## Application for Works Approval

<b>Works Approval Number</b>	W6595/2021/1
<b>Applicant</b>	Roy Hill Iron Ore Pty Ltd
<b>ACN</b>	123 722 038
<b>File number</b>	DER2021/000494
<b>Premises</b>	Roy Hill Iron Ore Mine  Mining tenements M46/518 and M46/519 NEWMAN WA 6753  As defined by the coordinates in Schedule 1 of the works approval
<b>Date of report</b>	27 July 2022
<b>Decision</b>	Works approval granted

#### **Zulu 6 in-pit TSF (Z6 IPTSF)**

**Figure 3: Cross section of Zulu pit area and Fortescue Marshes.**

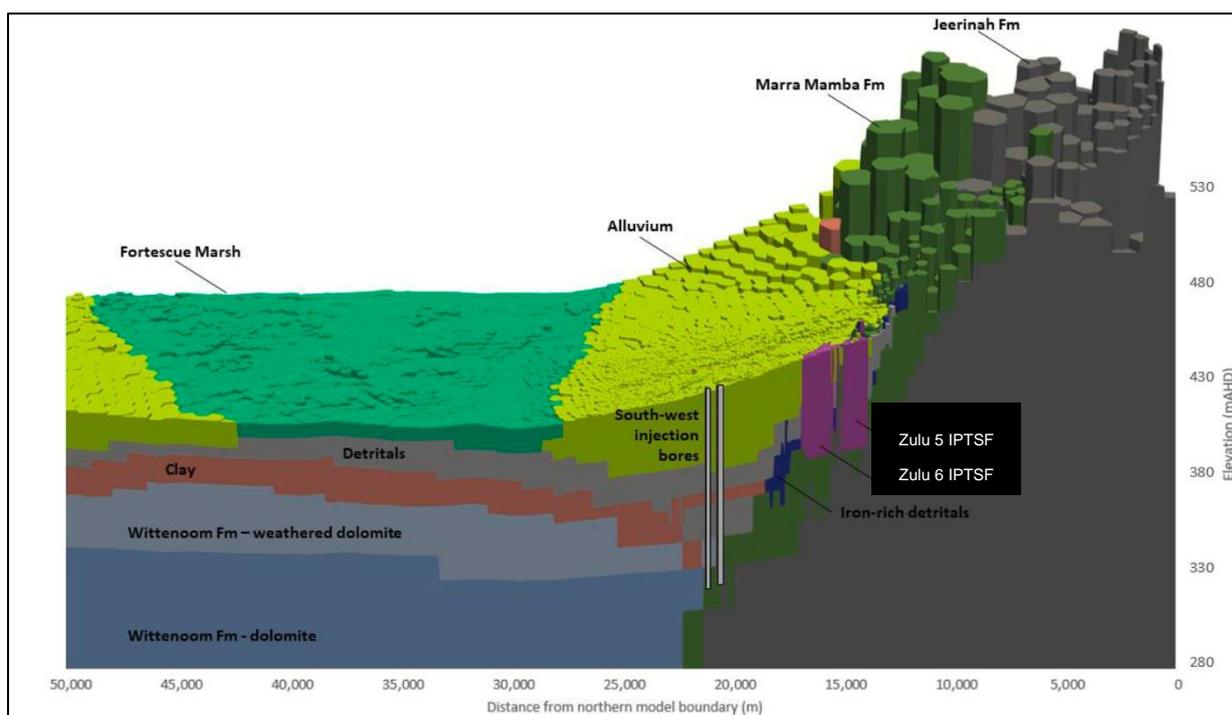
A series of abstraction bores and monitoring bores were constructed around the Zulu area. The bore logs around Zulu 6 IPTSF show that the top 10 to 28 metres is comprised of alluvium with lateral permeability between  $10^{-5}$  and  $10^{-6}$  m/s. This alluvial layer extends to the south and west of the pit all the way to the Fortescue Marsh. To the south-east, the alluvium connects to the non-perennial creek. Figure 3 shows a schematic of the geological formation around Zulu 5 and Zulu 6 IPTSF.

The monitoring bores around the Zulu area (RHPZ0117, RHPZ0119, RHPZ0242, RHPZ0314 and RHPZ0352) were installed to monitor the deeper aquifer (below 412 m RL). Most of them have very long screened intervals at a large depth. If lateral seepage is to occur through the gravel layer, groundwater samples from the existing monitoring bores would not produce meaningful results. Given that environmental receptors (riparian vegetation and groundwater) are most likely to be affected by poor water quality in the shallow alluvial aquifer, new bores with a short screened interval (less than 6 m long) must be constructed within this aquifer.

The GHD (2021b) report recommended two new monitoring bores, RHPZ0339 and RHPZ0507M. The department believes that the location for the new bores are appropriate but again the screening interval is very long for RNPZ0399 and both bores are targeting the deep aquifer. Also, monitoring bore RHPZ0352 has been destroyed and will need replacement.
